**Submission from the Maules Creek
Community Council (MCCC)**

**Maules Creek Coal Mine
Continuation Project**

Project Application Number: SSD-63428218

4.8.2025

Fig 4: Groundwater Data Graph presented to the CCC meeting in 2023

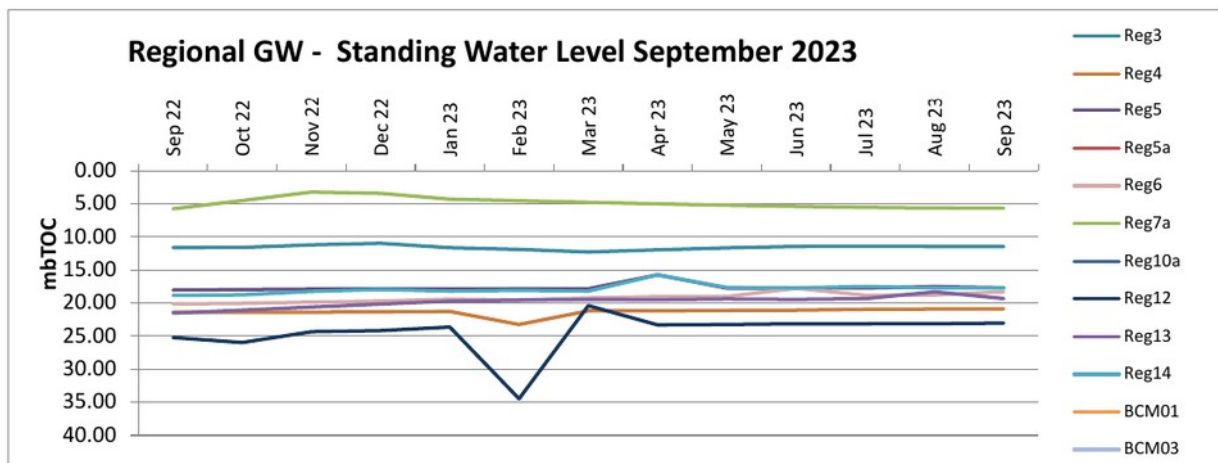
1.5.1 Lack of Bore Location Context

The chart provides no spatial context for the monitoring bores listed (e.g. Reg3, BCM01). Community stakeholders cannot determine which areas of the Maules Creek valley these bores represent, whether they are in the alluvium or hard rock, upgradient or downgradient from the mine, or in proximity to affected residences. Without spatial correlation, the dataset cannot be used to assess localised impacts or to verify consistency with the mine's groundwater model predictions.

aggregation masks differences in aquifer responses and prevents any meaningful interpretation of cause-effect relationships. Notably, several traces show sudden vertical shifts (e.g. BCM03), suggesting either abrupt drawdown or equipment error, but these are not explained or flagged.

To improve transparency and public confidence, the mine operator should be required to provide to the CCC:

Fig: 6 - Segment of MAC0067 exploration bore log showing Herndale and Braymont seams (Pacific Coal 1982)

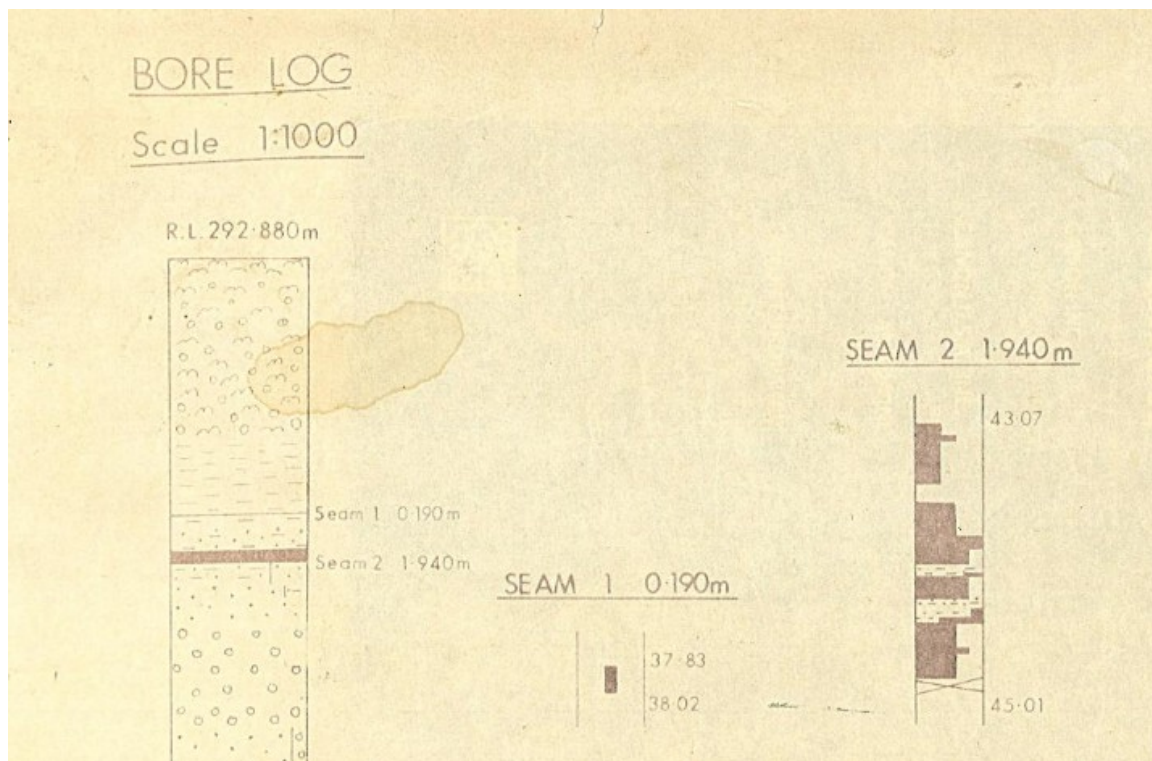
The section of Exploration Bore Log (Fig 6) from MAC67 in the Middle Creek - Horsearm Creek recharge area from 1982 show the top of the casing at 292.88 mAHD, the Herndale Seam at 37.83 mbTOC and the Braymont Seam at 43.07mbTOC. (Kembla Coal and Coke, Bore Log, MAC67 Maules Creek)

Based on the top of the Braymont seam at 43 mbTOC and the conceptualisation cross-sections DD and EE (AGE 2025) which show the MCA >50m, it appears that both the Herndale and Braymont seams would subcrop the alluvium at MAC67, and possibly across the entire MCA. This means there is evidence to support a direct pathway for mining depressurisation of the Braymont seam to propagate along the seam to the MCA.

Fig 6b: Visualisation of Braymont seam between Middle Ck and MCCC Pit

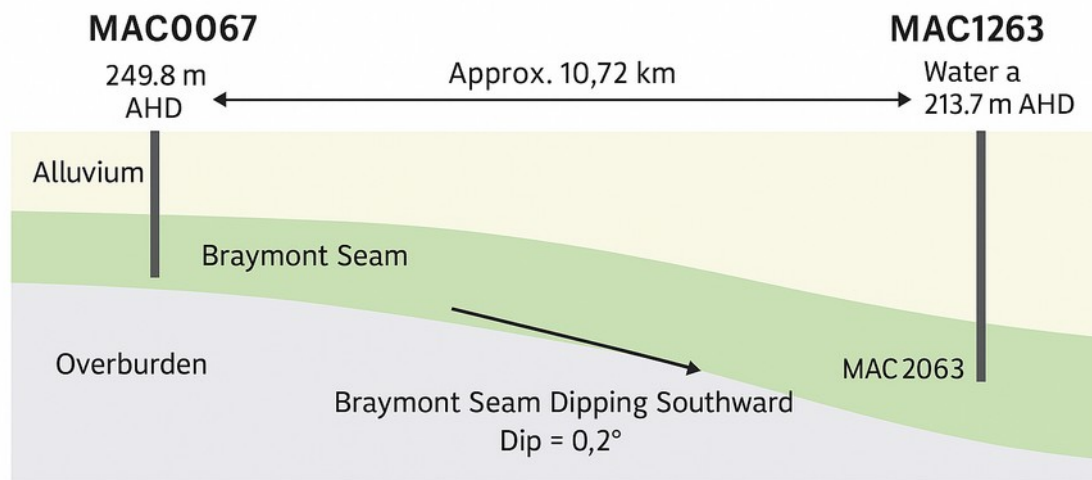
Ten kilometers north, in the Middle Creek area, MAC0067 intercepted the Braymont Seam at 249.8 mAHD, ~35m higher relative to sea level than MAC1263 in the MCCC pit. (Fig 6b)

This increase in height would increase hydrostatic pressure toward MAC1263 if the seam were continuous and hydraulically connected.

Fig 8: AGE 2025 Conceptualisation

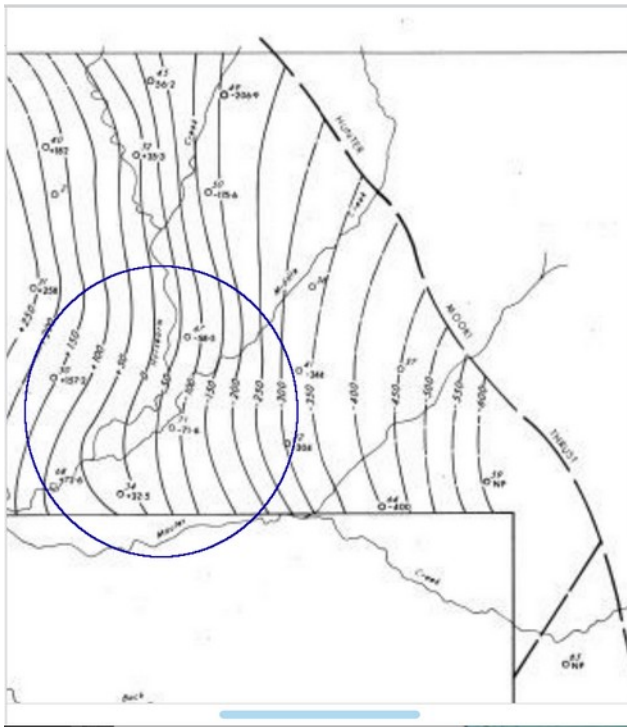
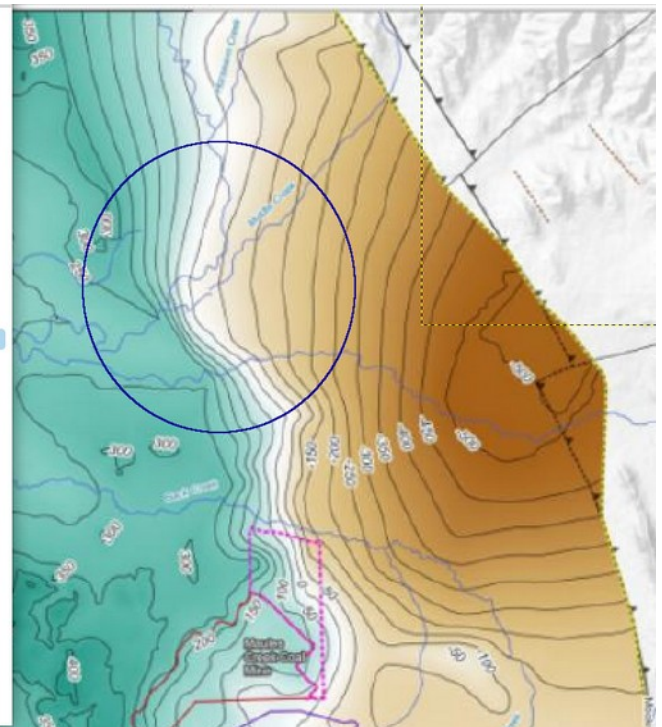
Figures 7 and 8 below show a second inconsistency (Inconsistency 2) introduced into the BTM Groundwater Model between the settled 1982 Pacific Coal Groundwater Conception Model and the 2025 AGE Conceptual Model.

Between the 2021 and 2025 modelling exercises, the proponent's conceptual modelling introduced up to 150 metres of vertical difference in volcanic basement contours across the Maules Creek area (Hydrogeologists.com.au (2025), p27). No new geological drilling or bore logs have been provided to justify this change, and the alteration appears to serve the modelled assumption of disconnection rather than reflect site conditions.

“Contrary to AGE (2025), the top of the Boggabri Volcanics represented in this exploration report does not show a steep gradient in the basement surface. At the confluence of Horsearm Creek and Middle Creek, the contours show that the top of the Boggabri Volcanics is interpreted to be at an elevation of approximately 50 mAHD. At this same location, the top of the Boggabri Volcanics in the AGE (2025) report corresponds to approximately 200 mAHD.

This difference is significant (150 m vertical difference) and has major implications for the geology that is presented in the groundwater conceptualisation, with further major implications on the numerical model layering and the resultant predictions.”
(Hydrogeologist.com.au, (2025) p26)

Figure - 7.49

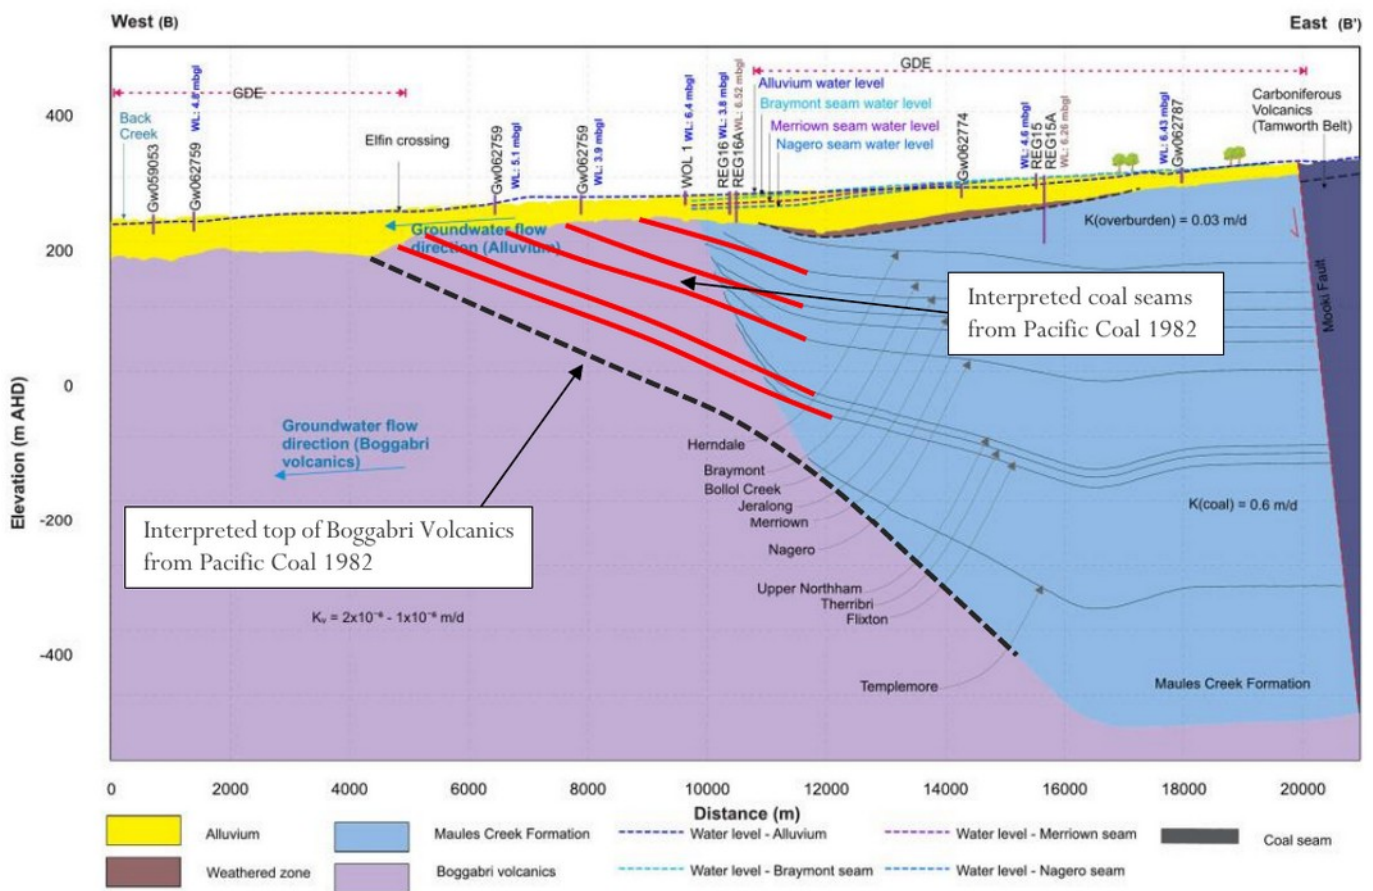
The AGE Conceptual Model (AGE (2025) p.45) pushes the Boggabri Volcanics east in the observed recharge area of Middle Creek and Horsearm Creek. By doing so, the conceptual model introduces a 150m high barrier into the numerical model to plug the recharge mechanism by disconnecting the Braymont and other coal seams from subcropping the alluvium, reducing the likelihood of aquifer drawdown. Fig 9 below shows the 1982 coal seams and Boggabri Volcanics in comparison to the AGE conceptual model.

Figure 5-1 Hydrogeological conceptualisation B-B' (AGE, 2025)

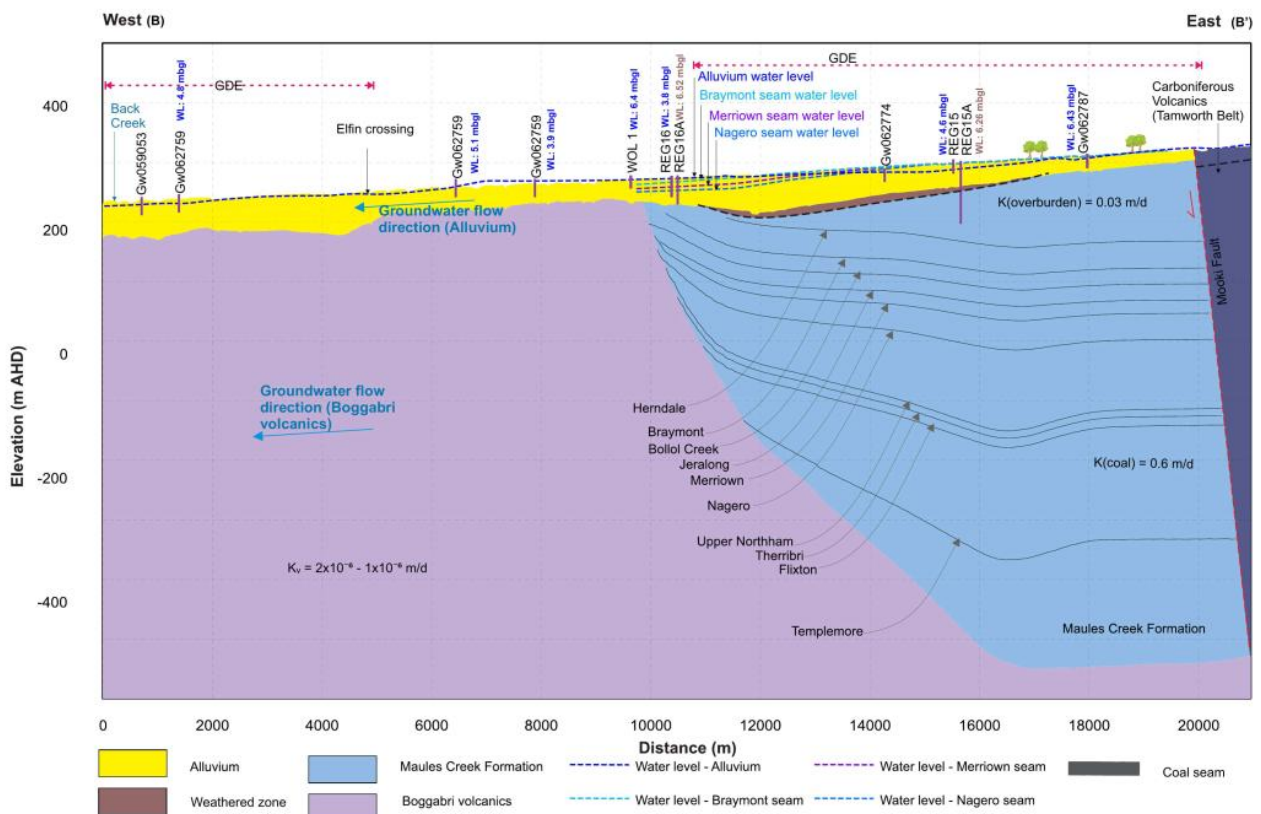
It is important to note that the described content cannot be found or substantiated in Appendix F. None of the hydrogeological conceptualisation sections presented demonstrate a potential hydraulic connection where coal seams directly sub crop beneath the Maules Creek alluvium, thus allowing a potential or hydraulic connection between the alluvium and the coal seams such as the Braymont Seam. The conceptual models, such as conceptualisation section B-B' (reproduced below as Figure 5-1) shows a strong disconnection. The alluvium is generally shown to be separated by low-permeability units. The Herndale and Braymont Seams terminate before they reach the base of the alluvium.

Hydrogeological conceptualisation B-B' (Figure 5-1) shows that there are limited groundwater bores penetrating the full thickness of the alluvium. Hence, there are limited bores that penetrate into the underlying Permian strata and Boggabri Volcanics. This reduces confidence in the interpreted stratigraphy and connectivity.

Figure 5-2 Alternative conceptual model schematic (Pacific Coal, 1982)

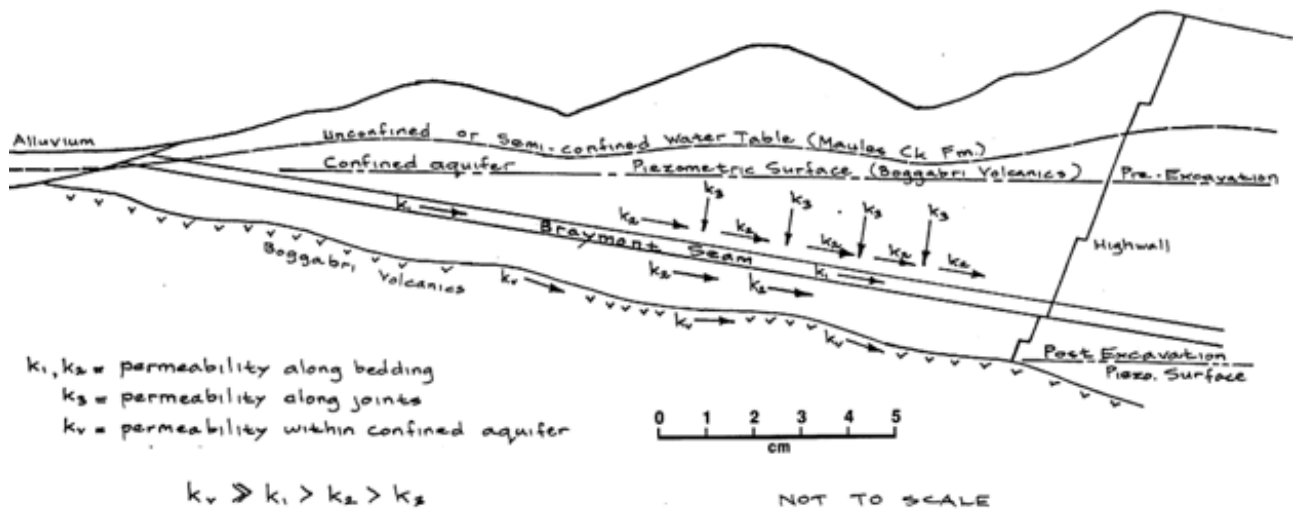
A conceptual model schematic is presented below from Pacific Coal (1982) to demonstrate the potential hydrogeological connections discussed above. Whilst it is recognised that the schematic is simplistic, the alternative conceptual model schematic (Figure 5-2) supports the AGE (2025) description of the potential connections between MCCM and the alluvial groundwater system existing north of MCCM where coal seams sub crop beneath the Maules Creek alluvium.

Figure 5-3 Hydrogeological conceptualisation D-D' (AGE, 2025)

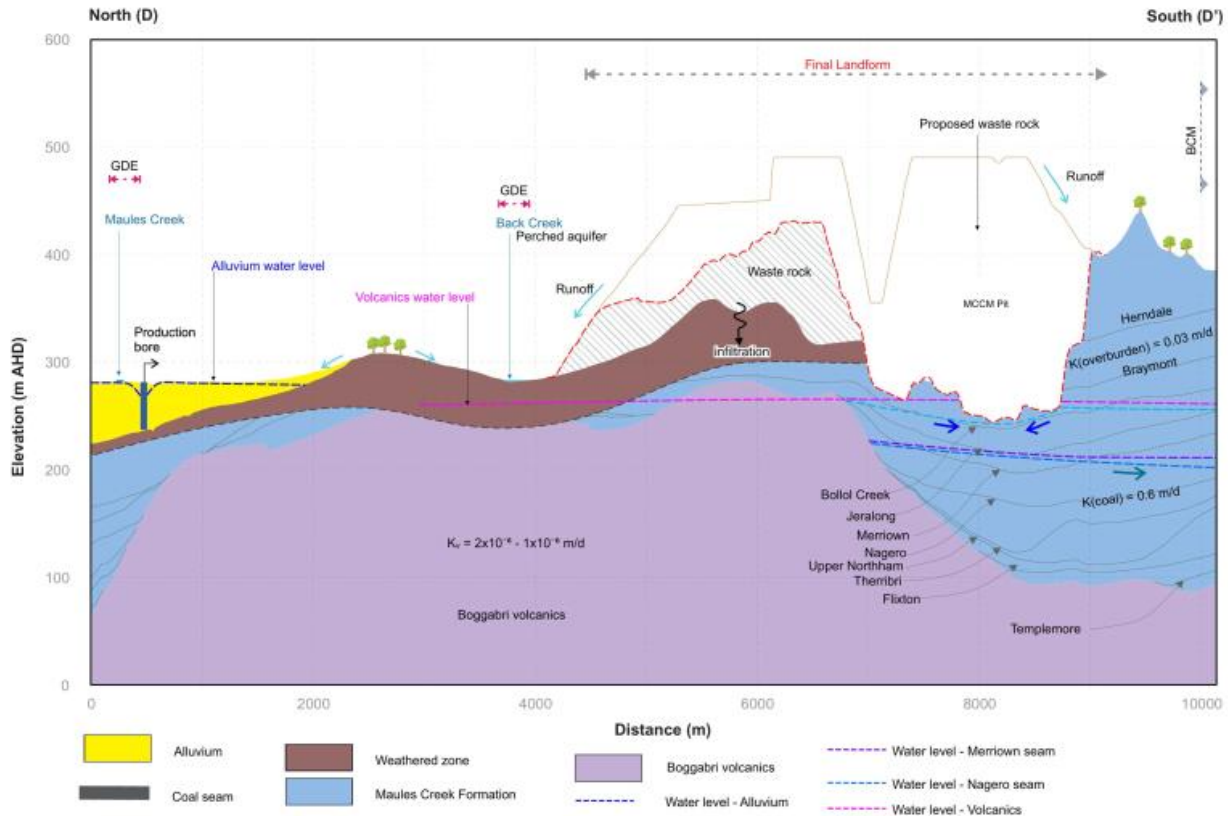
Hydrogeological conceptualisation D-D' is shown in Figure 5-3. The conceptual model does not represent any groundwater bores within the cross section. This limits the ability to validate the interpreted groundwater levels and geology.

The Boggabri Volcanic groundwater level appears disconnected from the weathered zone towards the alluvium but remains continuous towards the MCCM Pit. The alluvium exceeds 50 m in thickness (which is significantly different to the alluvium thickness that is shown in Figure 5.3 of AGE (2025)), and there is no separation depicted between the Narrabri Formation and the Gunnedah Formation, which is a critical component of the groundwater conceptualisation. The alluvial groundwater table is shown as being hydraulically disconnected from the Permian strata by the weathered zone. Further to this there is minimal information or data provided to support the thickness and extent of the weathered zone. Table 7.1 of AGE (2025) states that the weathered zone ranges between 1 m to 30 m thick, however hydrogeological conceptualisation D-D' shows the weathered zone to be at least 50 m or 60 m thick in some areas of the section.

Figure 5-4 Hydrogeological conceptualisation E-E' (AGE, 2025)

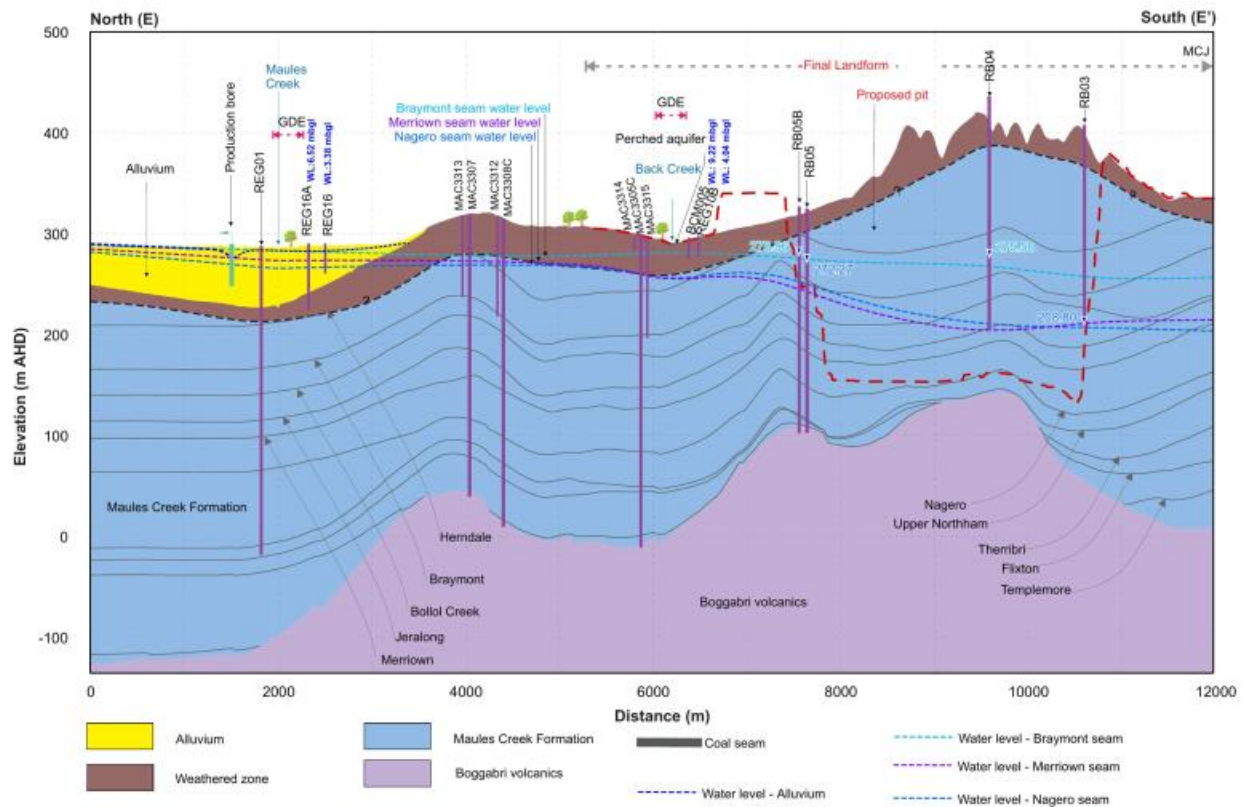
Hydrogeological conceptualisation E-E' shown in Figure 5-4 displays uncertainty in the weathered zone thickness south of REG16 (see use of question marks) and does not clearly define the connection between the alluvium and the sub cropping coal seams. The alluvium appears to exceed 50 m in thickness, and there is no distinction or separation shown between the Narrabri Formation and the Gunnedah Formation. The weathered zone is noticeably thicker near the alluvium, particularly in the northern part of the cross-section around Maules Creek. There is minimal data available to show the weathered zone as the main pathway for lateral groundwater flow from the alluvium to the coal seams.

The conceptualisation that the weathered zone represents the primary lateral groundwater flow pathway between the alluvium and the underlying coal seams is not substantiated by data. The conceptual model does not present dedicated monitoring bores, hydraulic head measurements, or permeability data within the weathered zone to verify lateral connectivity. Further information or data is required for the weathered zone beneath the alluvium, and between the alluvium and the MCCM to confirm pathways for groundwater flow between the alluvium and the coal seams.
